13 August 2021

Re: St John of God Richmond Hospital Redevelopment (SSD-10394) Response to Submissions

Lew Short | Director
Blackash Bushfire Consulting

Attachment 3 Residence 4 Reposition and Internal Layout

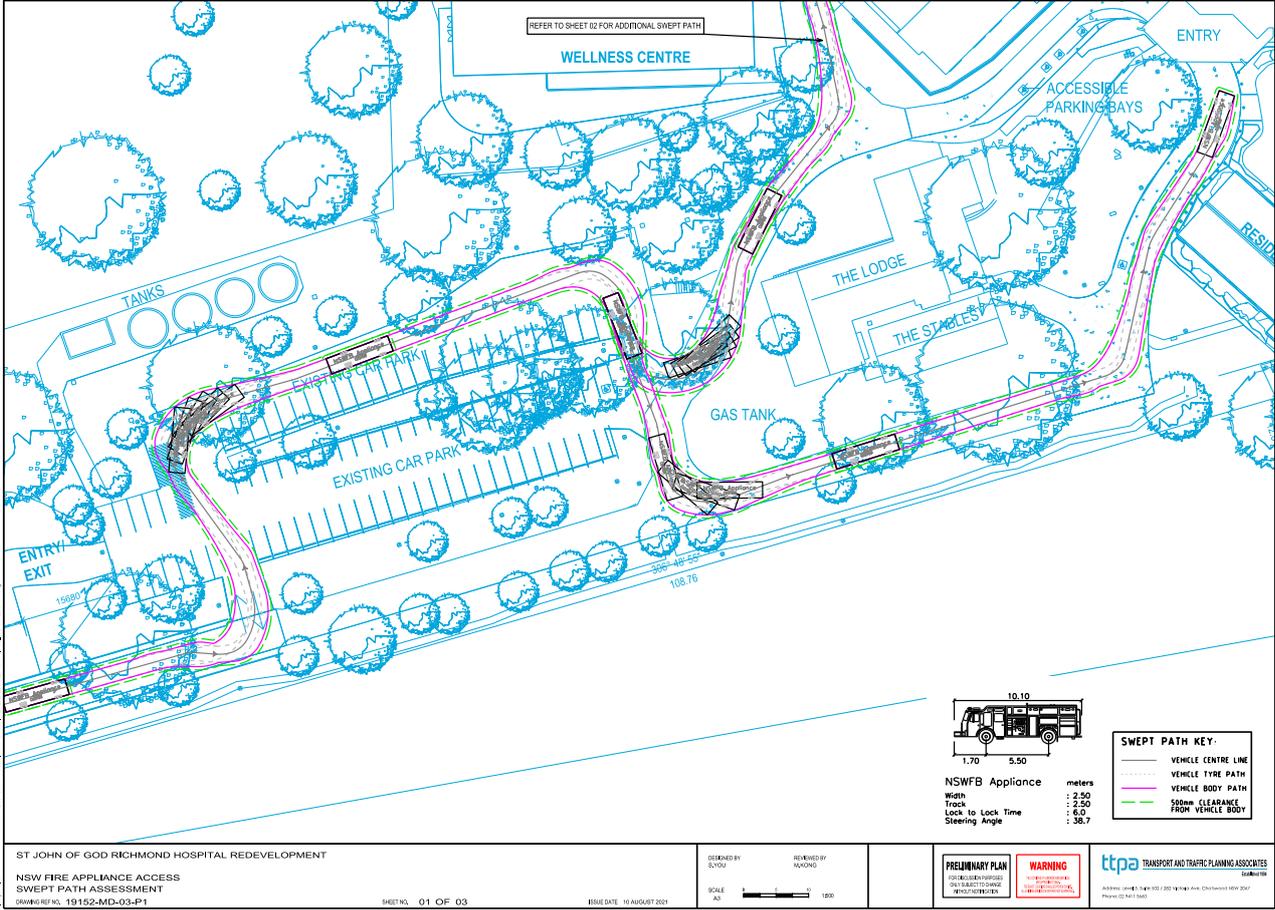
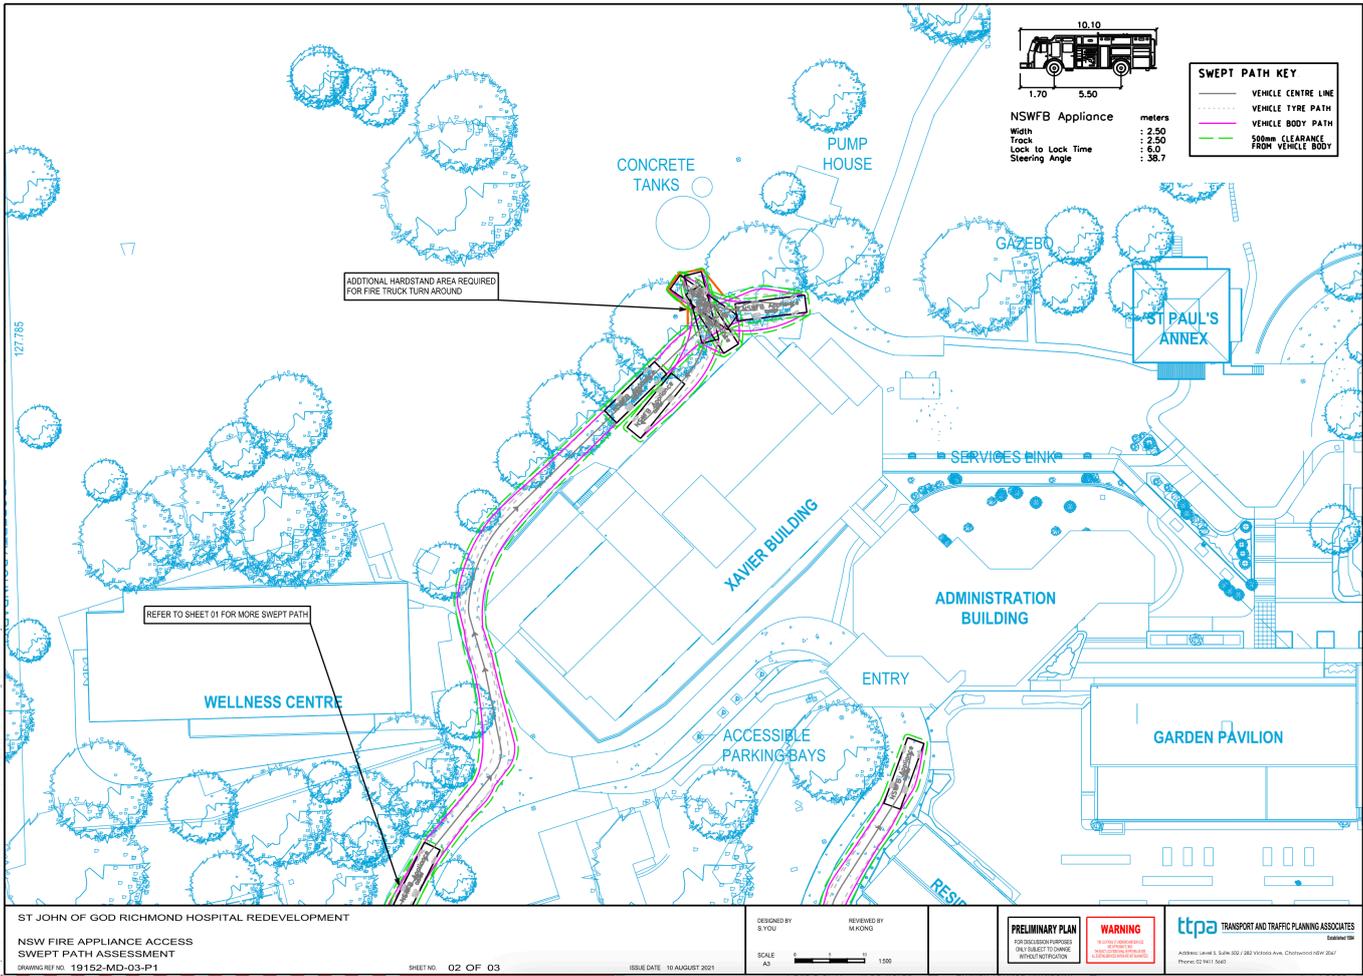
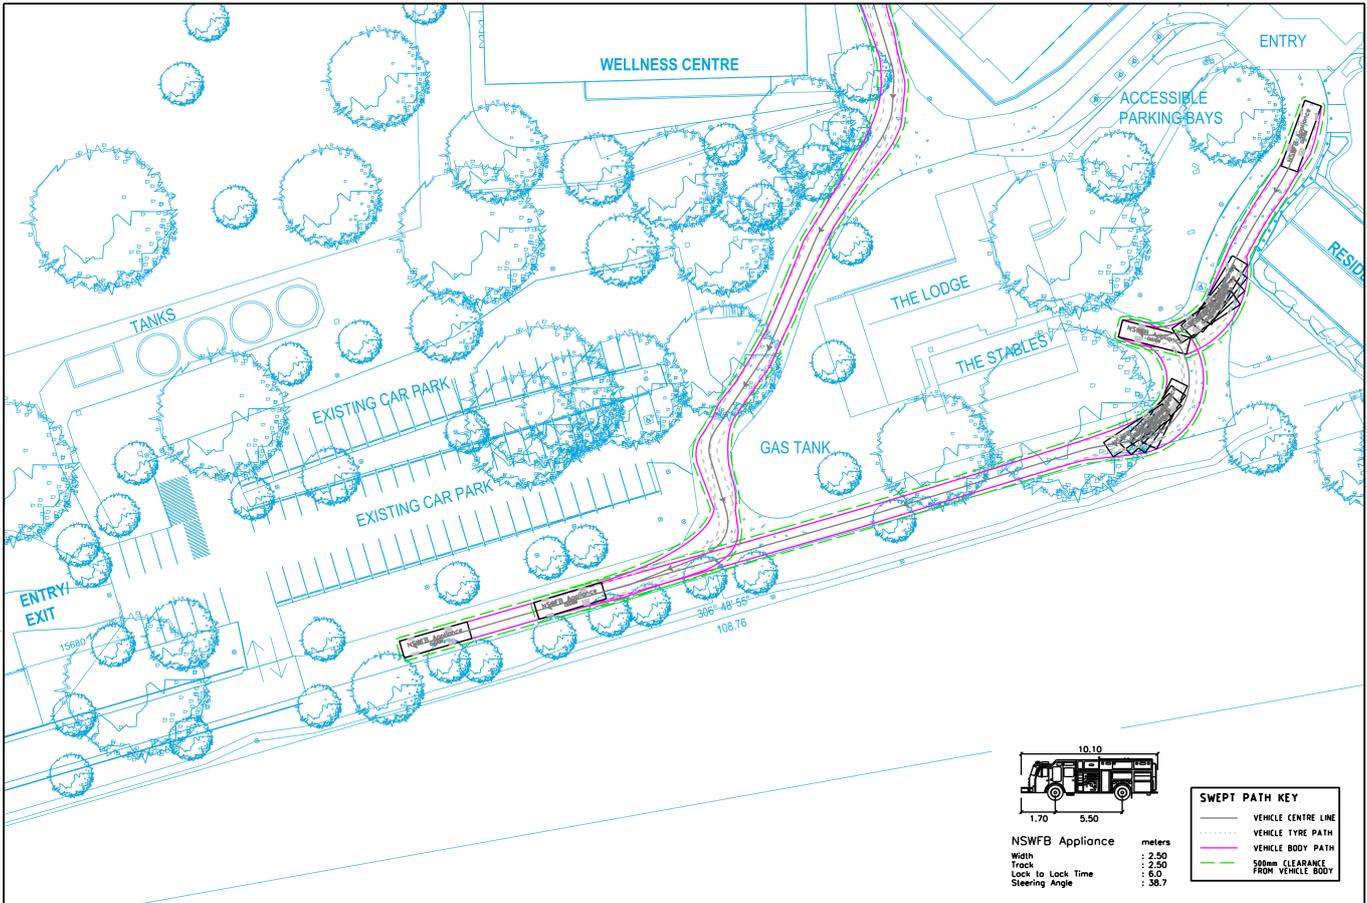
4. *Address the appropriateness of the proposed Wellness Centre and two of the proposed Residential Pavilions located within BAL-FZ – the proposed construction requirements are not commensurate with their location.*

Following the discussion with DPIE on the 4 August 2021, St John of God have repositioned Pavilion 4 (see Attachment 1) so that it is within the existing building footprint and the Wellness Centre (see Attachment 2) to be at BAL 29. Attachment 1 shows the existing buildings and the proposed redevelopment with commensurate Bushfire Attack Levels (BAL) across the site shown at Attachment 5 and 6.

The buildings have been located having regard to the infill provisions within PBP. Following consultation with DPIE, the Wellness Centre has been moved to 13m from the boundary and is within BAL 29. Pavilion 4 has been repositioned to be no closer to the hazard than the existing building line. See Attachment 1, 2, 5 and 6.

Attachment 4 Fire Brigade Access for MR Vehicle within the site

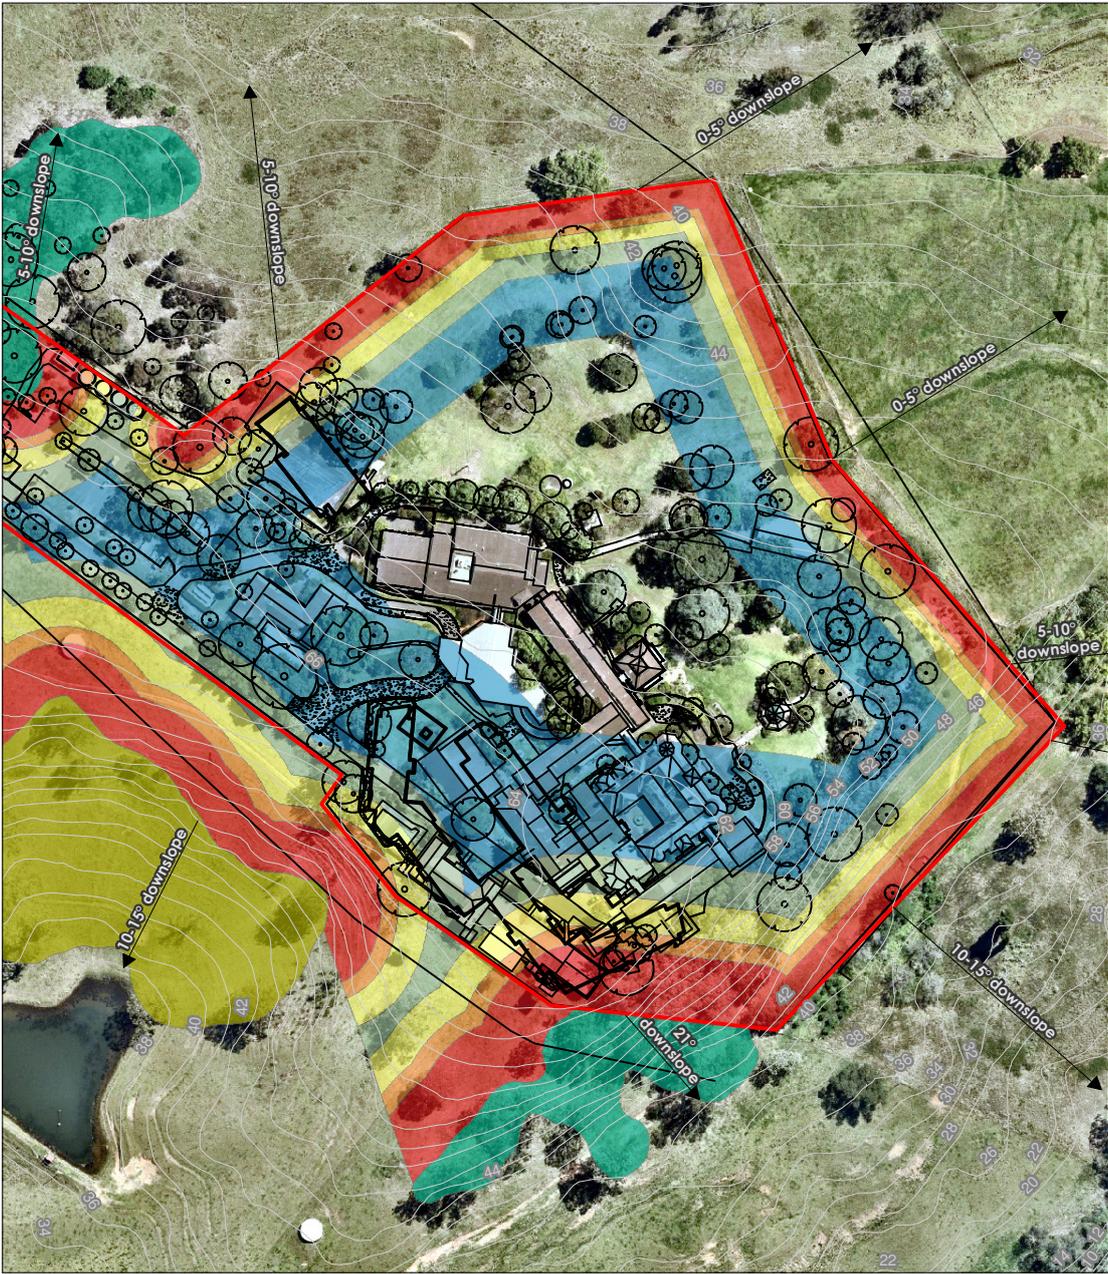
1. *Provide a complete assessment of the facility as a whole and how the proposal achieves a 'better bushfire outcome' for the existing facility, taking into account the intensification in use and access/evacuation arrangements. Belmont House should be included within this assessment.*

Access is provided within the site for MR fire appliances. A swept path analysis is provided at Attachment 4 showing access throughout the site.
